Official Transcript of Proceedings
NUCLEAR REGULATORY COMMISSION

Title: Advisory Committee on Reactor Safeguards
Advanced Boiling Water Reactor
Subcommittee

Date: Wednesday, April 6, 2011

ADVANCED BOILING WATER REACTOR SUBCOMMITTEE

Figure 10.2-5 Turbine Overspeed Trip System Functional Diagram

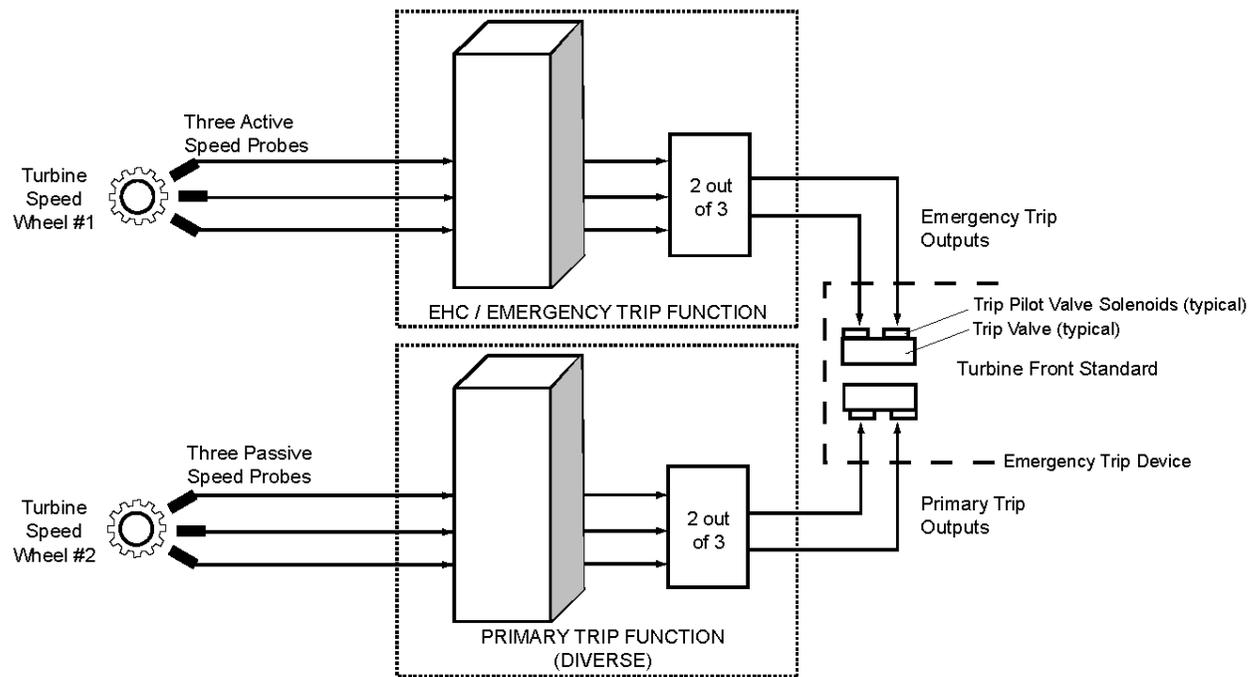
11 MEMBER BROWN: Okay. I just want to make
12 sure after going through this and the clarifications
13 you all added to the RAI. There are three active
14 speed sensors that are also used for the normal speed
15 control?

6 MR. MURRAY: What I mentioned was if they
7 exceed setpoint. But also in the information we
8 provided, yes, if you have one failure, you do not get
9 a turbine trip. You go to a two out of -- or you
10 reduce the logic -- go two out of three. But a second
11 failure of a speed probe will provide a trip.

1 You made a comment and it's in your RAI in
2 the context, it says -- it's talking about the normal
3 speed control units. And these are the active
4 sensors. And John addressed what's a failure. But it
5 says if you lose any two of the speed sensors -- the
6 active sensors -- then you will initiate a turbine
7 trip.

8 Whatever the mode of failure, we haven't
9 got that defined as to what defines a failure, et
10 cetera. And in my previous reading, I kind of felt
11 that applied to the primary diverse system also. But
12 then I went back and looked through and I could not
13 find that in the RAI response, anything that addresses
14 the passive sensors such that if two of them fail --
15 whatever the mode either -- there's no output or the
16 output goes bananas or whatever the thing is that
17 stays in one place -- couldn't find any reference to
18 if you lost sensing on the primary system that you
19 would get a turbine trip. So am I wrong?

3 MEMBER STETKAR: I think, Dinesh, my
4 questions to the Applicant kind of get to the point of
5 what happens if a speed signal -- two out of three
6 speed signals go to zero speed is basically what I was
7 looking for.

3 The picture we've got here in front of us
4 will be will be added to the FSAR. It's a simplified
5 diagram of the two overspeed trip functions -- how
6 they're implemented.

RAI 10.02-4 revised response added a figure to FSAR Section 10.2:

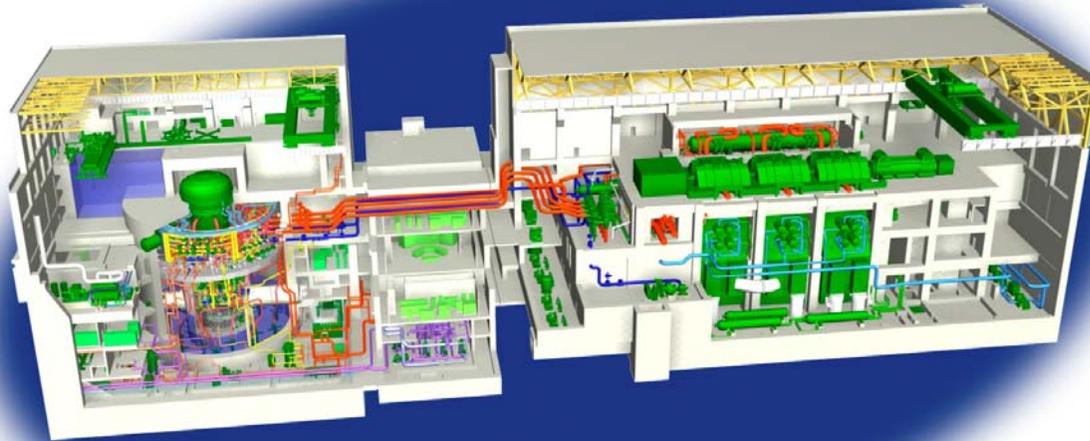
14 In reviewing that change, we looked at the
15 Tier 1 information, and there appeared to be an
16 inconsistency between the Tier 2 information and the
17 Tier 1 information which they had incorporated from
18 the DCD by reference.

19 The first slide here pretty much
20 summarizes what the issue was when we came and talked
21 to you last time at the ACRS meeting. And basically
22 like I just said, we had a Tier 2 change that changed
23 system configuration, and the Tier 1 information still
24 reflected the DCD information which didn't incorporate
25 condensate feedwater system that utilizes a booster

3 In resolution, they provided us with a
4 revision to one of our earlier RAIs. And in that
5 revision what they did was they revised the figure
6 that the design description pointed to -- or the ITAAC
7 pointed to design description figure to confirm that
8 the system in the ITAAC was the system that we were
9 approving in the design. And they updated that
10 figure, and now the figure shows the condensate pump
11 -- the relative location of the condensate pump. And
12 it includes the condensate, moves the pump into Tier
13 1 figure.

- The applicant proposed a new Tier 1 departure which revised Tier 1, Figure 2.10.2a.
- In the revised Figure 2.10-2a, condensate booster pumps are now included as part of the basic CFS configuration.
- The staff reviewed the proposed revisions to the Tier 1 information and found it acceptable since the information in Tier 1 is now consistent with the plant design described in Tier 2.
- Incorporation of the proposed Tier 1 change is being tracked as a confirmatory Item.

Primary Overspeed Trip and Emergency Overspeed Trip Functions

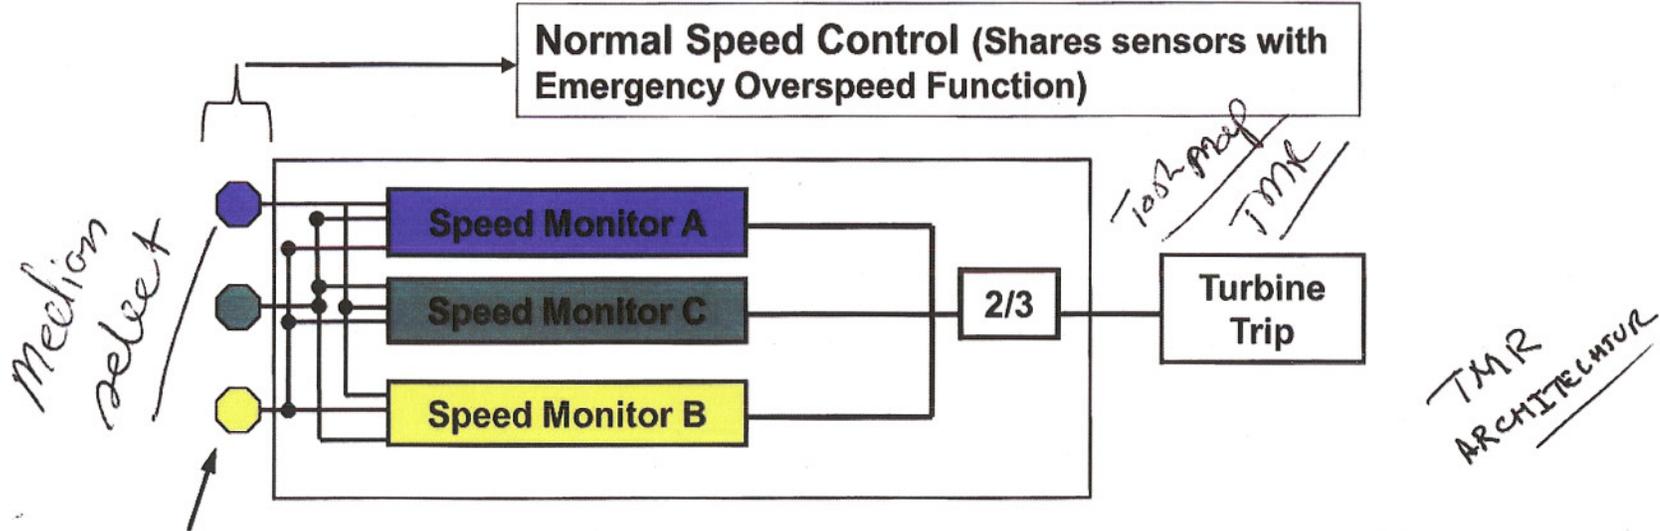
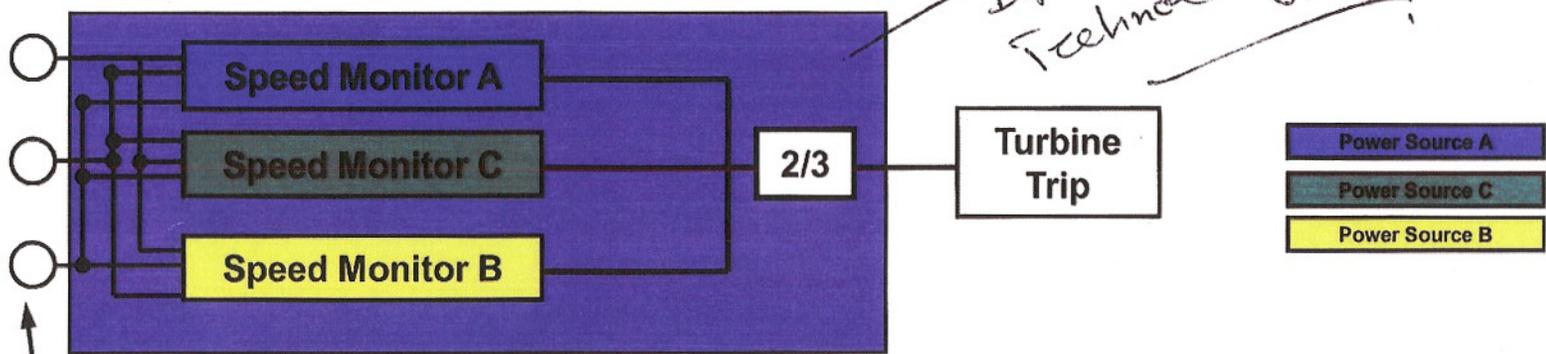
17 But the primary as the picture will show
18 is done in a very similar fashion. Again, it's still
19 diverse in the particular modules that do it. But
20 each module senses the speed sensor -- all three
21 speed sensors.

3 Speed Pickups (Active) for Emergency Overspeed Trip Function
(Active detector needs power supply)

3 Speed Pickups (Passive) for Primary Overspeed Trip Function
(Each passive detector needs no power supply)
